# **DART SERVICE INSTRUCTION**

**TO AMEND INSTALLATION INSTRUCTIONS IIN-D135-751 REV. C OR LATER APPROVED REVISION AND  
INSTRUCTIONS FOR CONTINUED AIRWORTHINESS ICA-D135-751 REV. 2 OR LATER APPROVED REVISION**

REF. FAA STC: SR01709SE

**FIGURE 1 - DRILLING DETAIL**

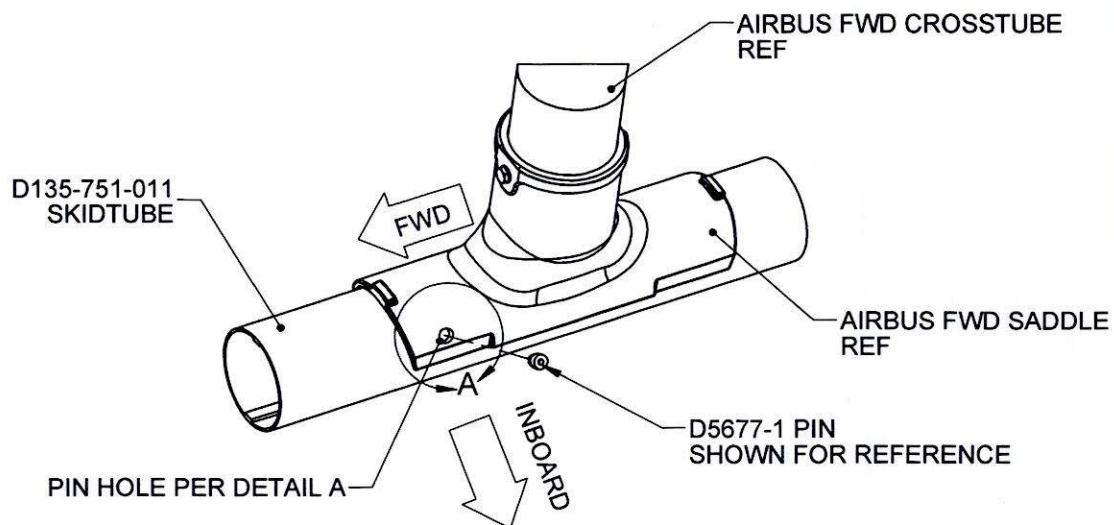
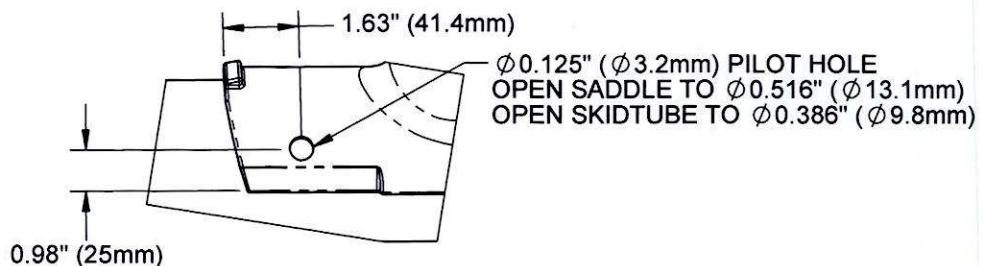
- 2.1 Pilot drill Ø0.125" (Ø3.2mm) through the forward saddle per Figure 1, Detail A of this service instruction.
- 2.2 Temporarily position and secure the fwd saddle onto the skidtube per Figure 1 of IIN-D135-751. Ensure the saddle is positioned correctly and that the skidtube will be vertical with weight on the landing gear. Transfer mark the pilot hole onto the skidtube.

- 2.3 Remove skidtube and open the saddle hole to Ø0.516" (Ø13.1mm). Open the hole in the skidtube to Ø0.386" (Ø9.8mm). Deburr holes and touch up with chemical film (Alodine 1200) per MIL-DTL-5541.

**FIGURE 2- D5677-1 PIN INSTALLATION**

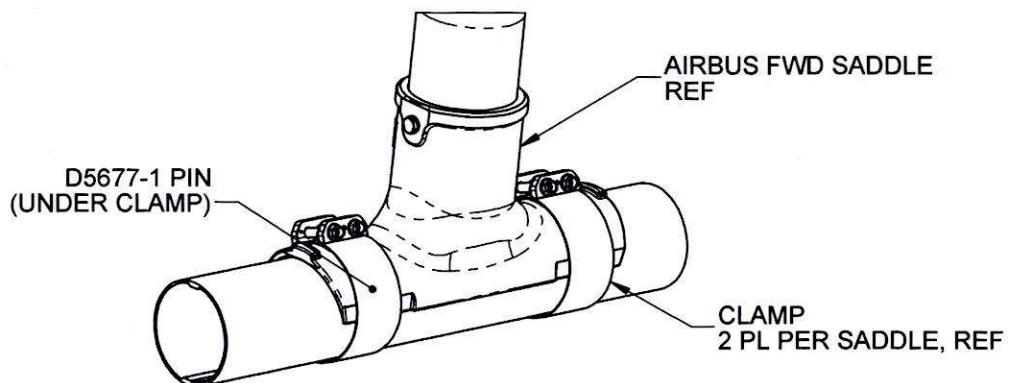
- 2.4 Continue the installation of the skidtube per Section 3.1.3 of IIN-D135-751. However, ensure the D5677-1 Pin is installed under the fwd clamp of the fwd saddle as shown in Figure 1 & 2 of this service instruction. Seal the surface between the pin and skidtube with Sikaflex-241/-291 or Proseal 890 or MIL-S-8802 Class 'B2" sealant.

- 3.1 When reinstalling the D135-751-011 Skidtube Installation per Section 32.2 of ICA-D135-751, ensure the D5677-1 Pin is installed under the fwd clamp of the fwd saddle per Figure 1 & 2 of this service instruction. Seal the surface between the pin and skidtube with Sikaflex-241/-291 or Proseal 890 or MIL-S-8802 Class 'B2" sealant.
